# Outcomes of the DTT Vacuum Vessel Design Review

Mauro Dalla Palma on behalf of the  
DTT Vacuum Vessel and Ports Team

CTS-DTT meeting in Frascati

July 11-12, 2022

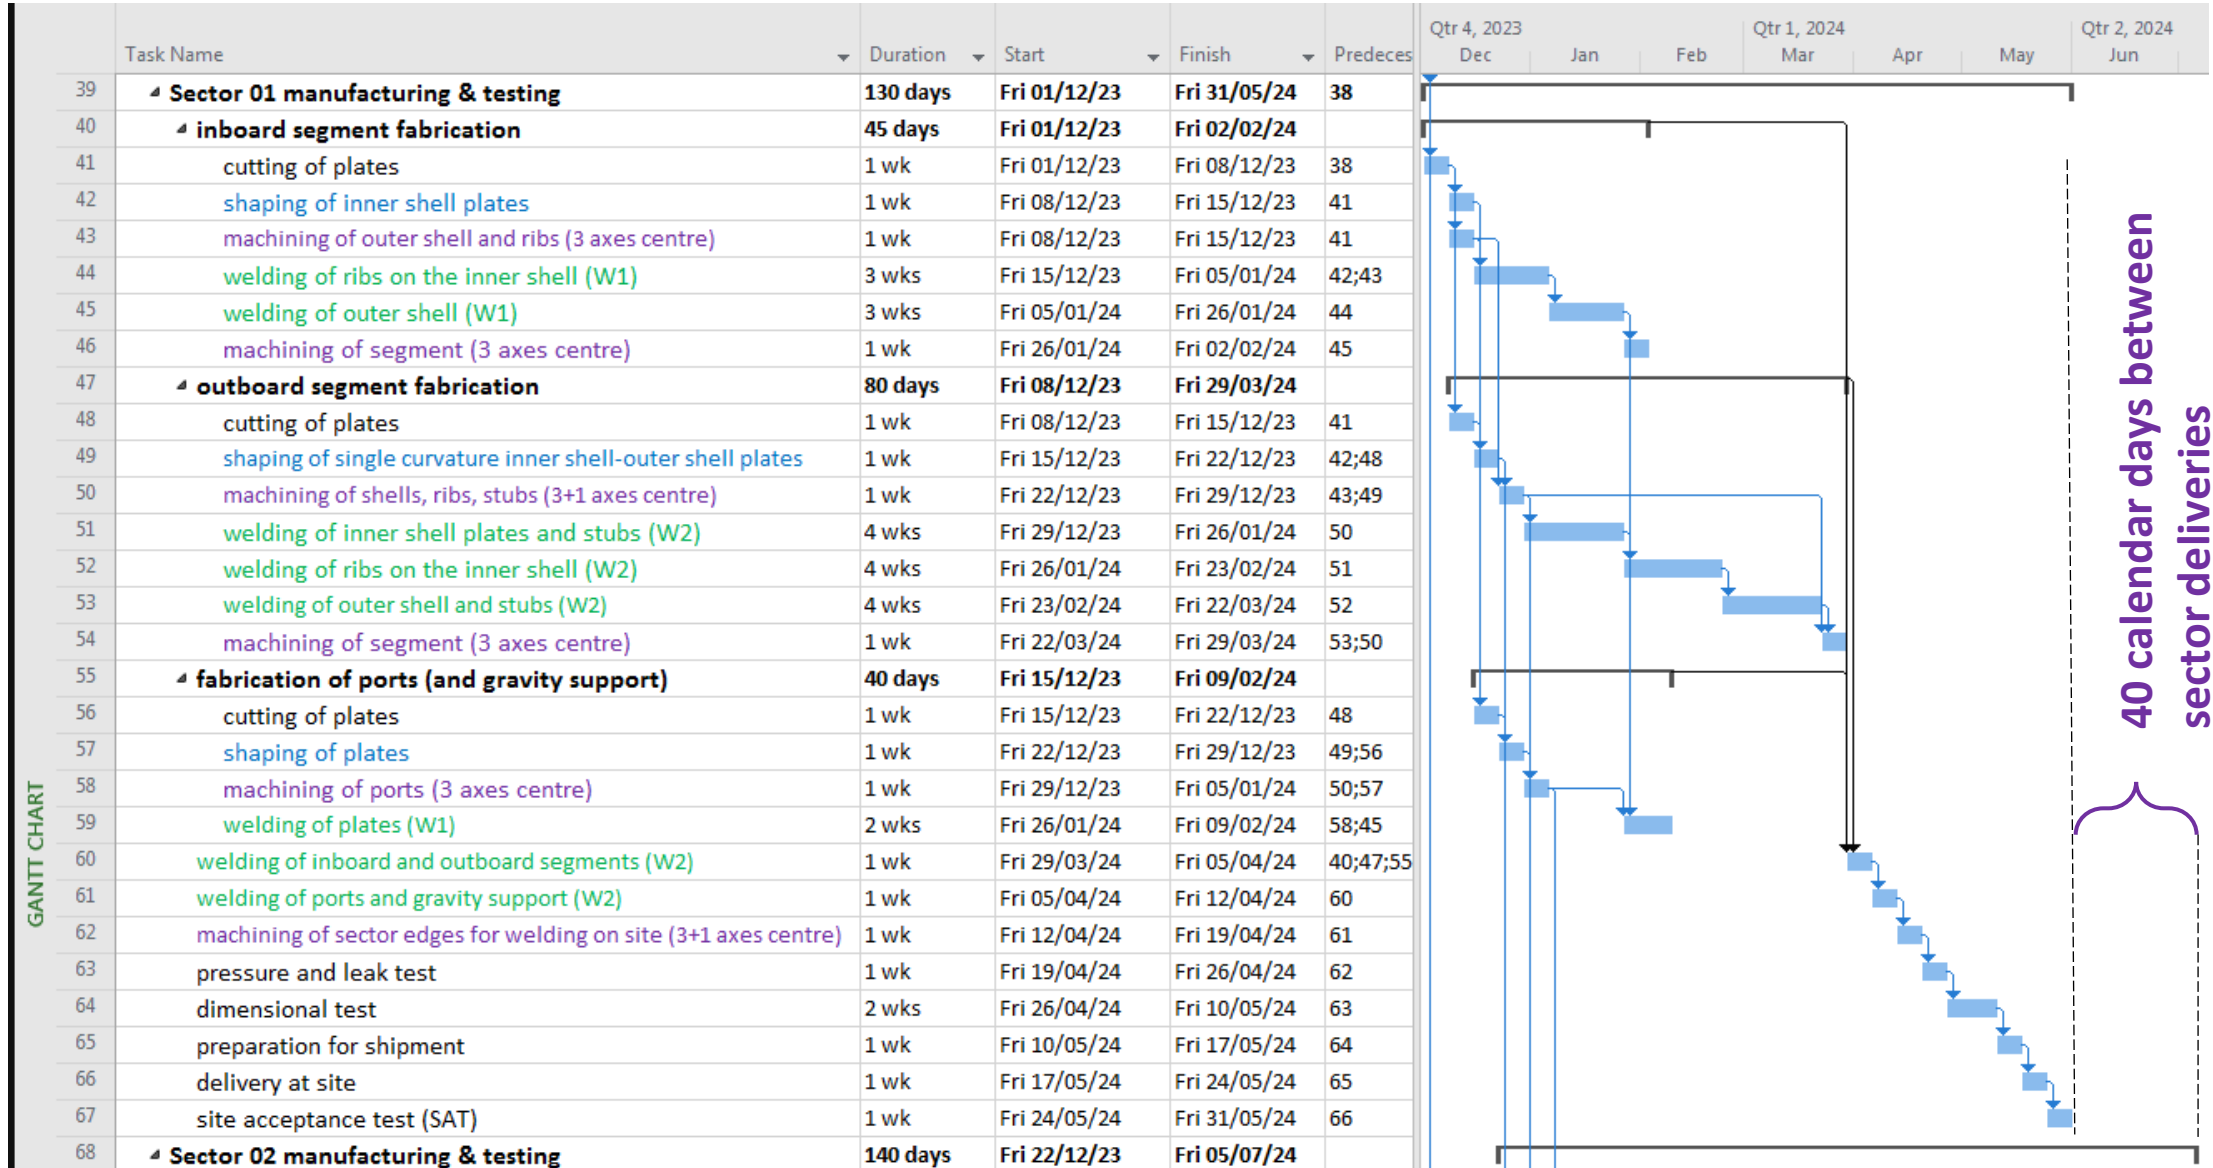
*The Panel noted that the production sequence appears very tight, with a great deal of parallel manufacturing stations ...; in addition no timing contingency has been considered in the critical path.*

*The Panel believes that the probability of completing the fabrications of the VV, ports and gravity supports in 40,3 months is low.*

- To consider a duration of the procurement contract of 45 months in agreement with the previous estimation of an independent panel;*
- To carefully verify that the chosen company has relevant experience in this type of fabrication, the equipment necessary to perform all the manufacturing steps and can guarantee the presence of the required experts in the different areas during the work.*

Actions are ongoing in DTT in order to mitigate the planning criticalities:

- Evaluation of the VV manufacturing strategy and revision of the on-site integration sequence of VV sectors.

# Design and manufacturing - qualification of processes

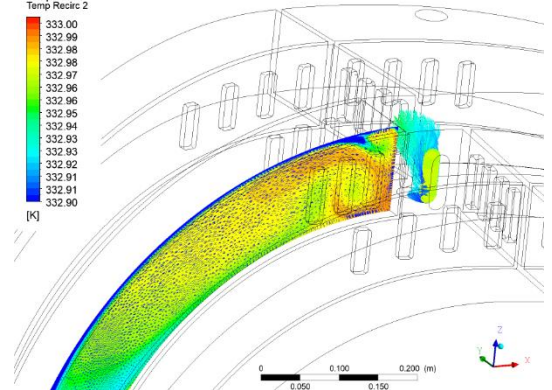
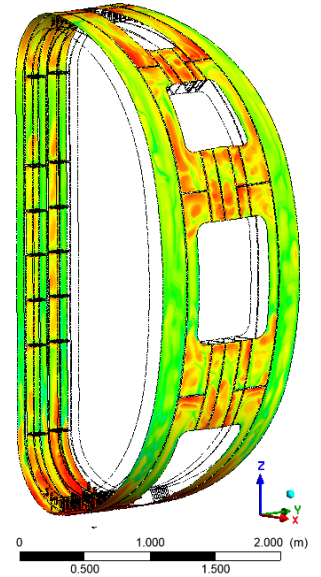
- *qualification plan for the control of deformations during the welding process;*
- *qualification of all the non-destructive tests;*
- *weld and welder qualification;*
- *procure 316LN for the fabrication of two prototype sectors.*

# Analyses - thermal-hydraulic

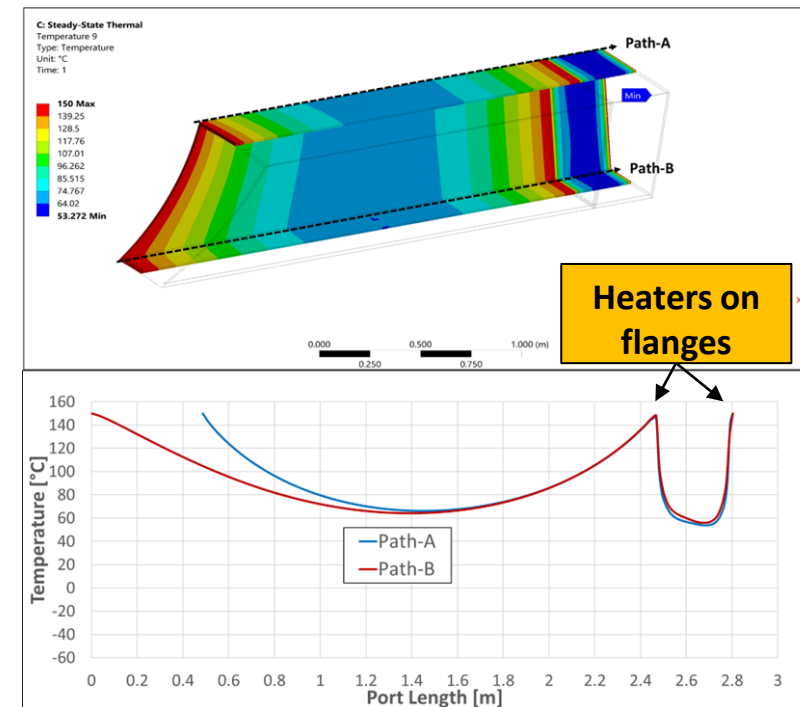
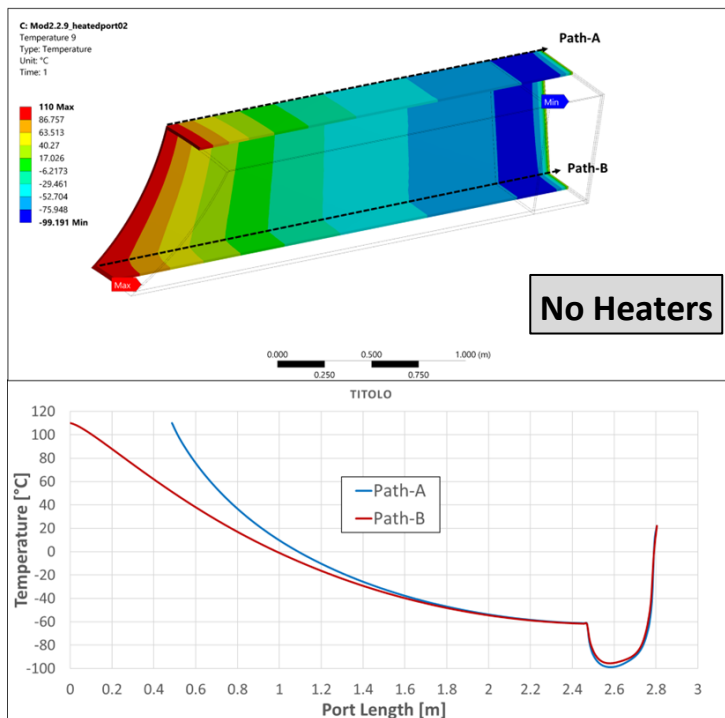
*The Panel recommended the DTT Team to ensure that the described analyses are completed in the next few months in order to be able to introduce the necessary modifications (if needed) before the revision of manufacturing drawings.*

## Sleeve on bellows

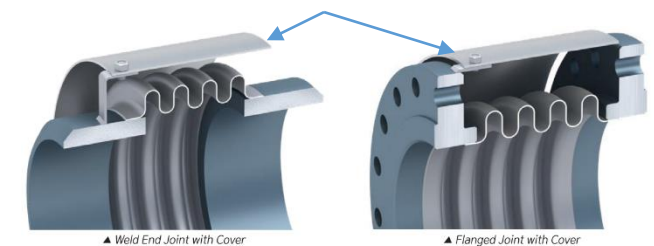
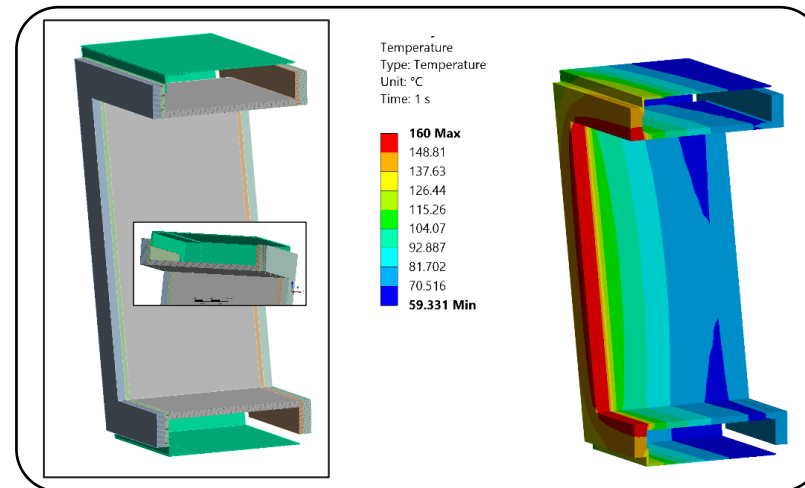
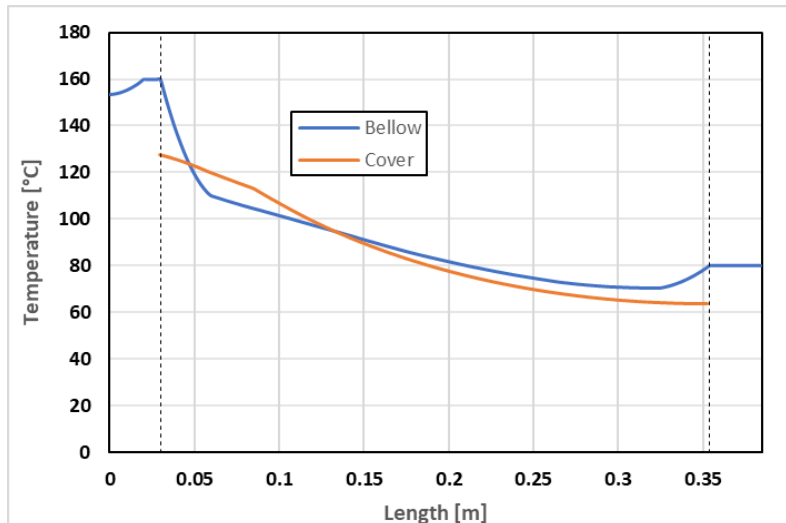
- heating cables to be placed in contact only with bellows flanges
- an external sleeve could be needed

**VDE + Earthquake**

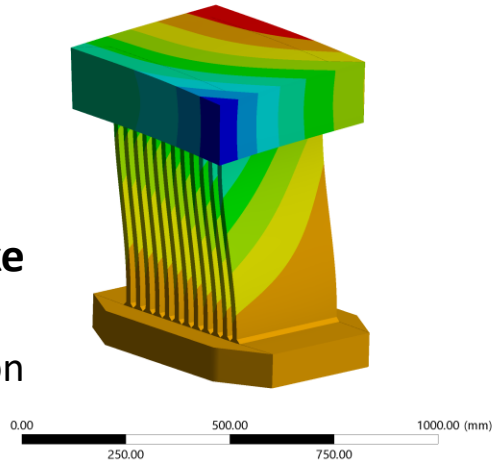
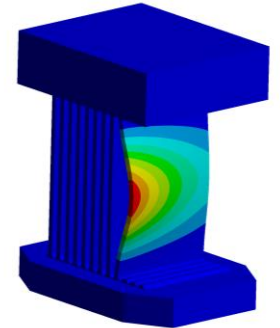
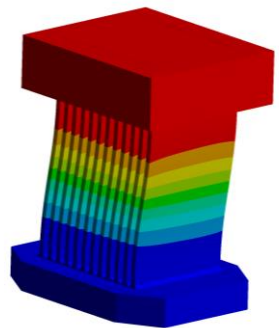
- *the design should be improved so as to increase significantly the load multiplication factor;*
- *the fatigue verification should be completed before the revision of manufacturing drawings is prepared by the vessel supplier.*

## Interfaces - Divertor, Limiter, First Wall

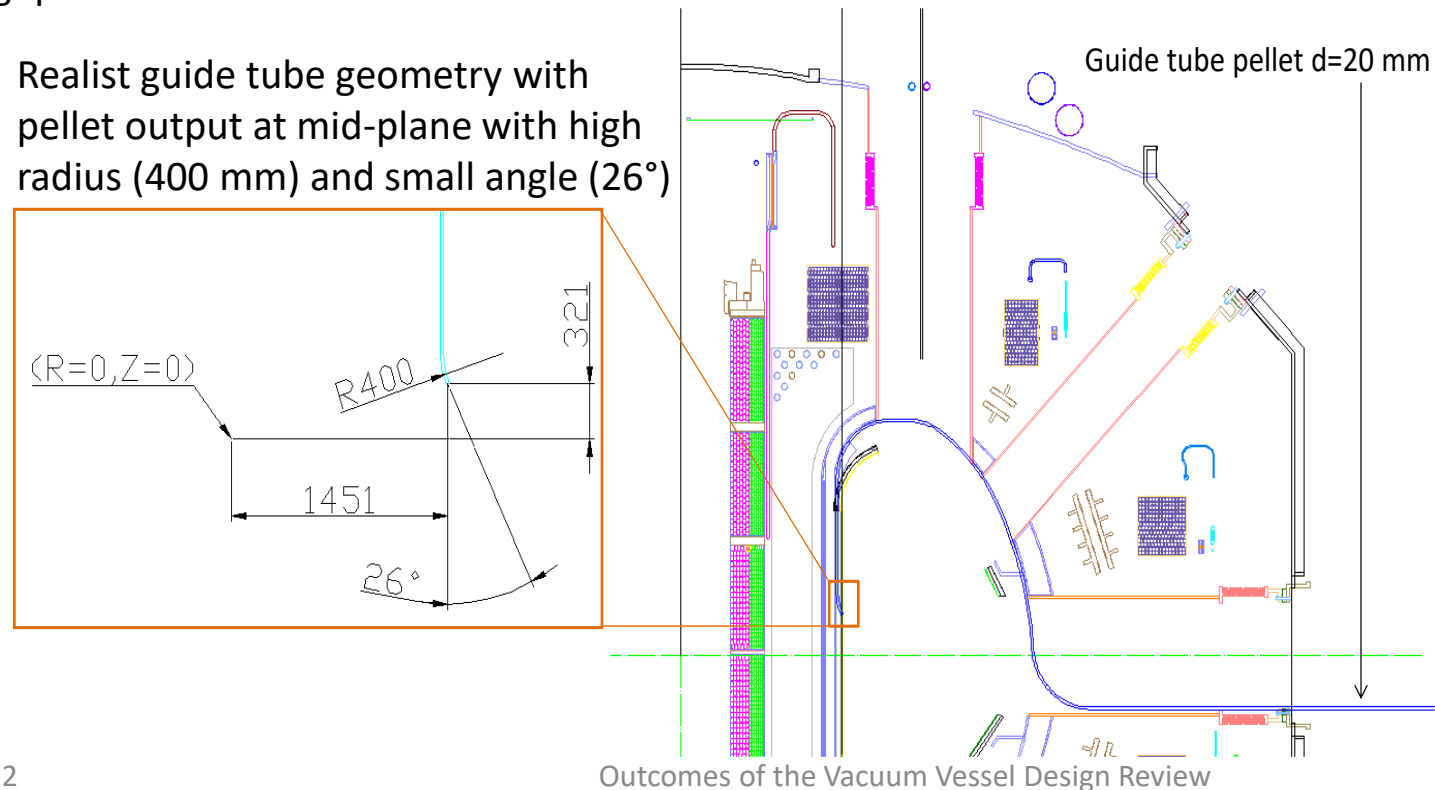
- To accurately verify the drawings of all the supports of the in-vessel components in order to be sure of their suitability to function properly in every operating condition of the DTT machine. Such analysis is recommended to be performed before the design review of manufacturing drawings is prepared by the VV supplier;*
- To pay particular attention to the design and verification of the divertor locking-alignment system;*
- To check with the physics group that there will be sufficient gas conductance through the divertor structures for the required divertor exhaust pumping speed to be achieved;*
- To verify in detail the FW / Limiter designs, their attachments and the loads acting upon them.*

Suitable actions are ongoing regarding all these topics.

# Manufacturing and integration tolerances

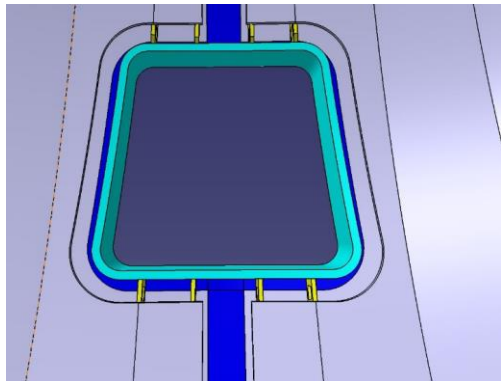
*The Panel notes that a worst-case combination of non-conformities on the VV dimensions could bring the FW limiter to a radius  $R > 1460$  mm resulting in a possible plasma performance reduction.*

*The Panel recommended the DTT Team to discuss with the physics group the possible impact on the plasma performance of operationally reducing the minor radius and/or increasing the major radius so that the inboard radius of the separatrix ( $R_0 - a$ ) increases by a few mm.*

*Another possibility is to mitigate this criticality by specifying asymmetric tolerances of the vacuum vessel on the inboard side in order to divide the available free space of 10 mm between VV and TFC so as to preserve the critical clearance lying between the VV and the plasma.*

Suitable actions are ongoing considering also the VV manufacturing strategy and revision of the on-site integration sequence of VV sectors.

# Assembly

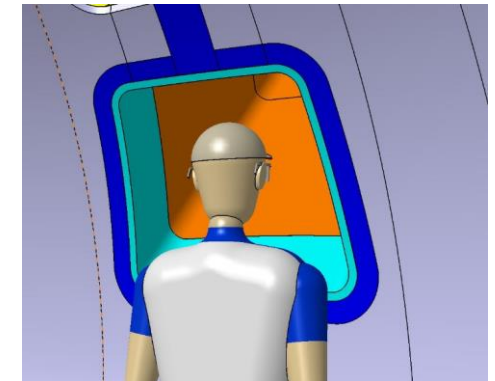
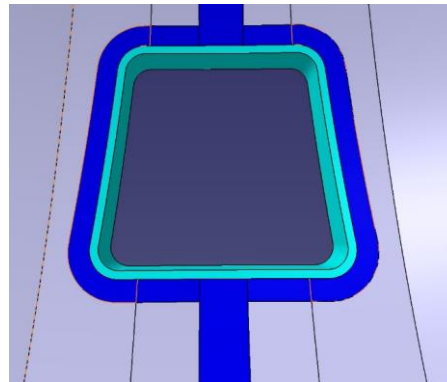
- *To analyse in detail the assembly of the final sectors for the closure of the VV;*
- *To install in the final assembly phases port stubs and port ducts already prepared in one piece each; i.e. to avoid their installation on the VV in two pieces.*
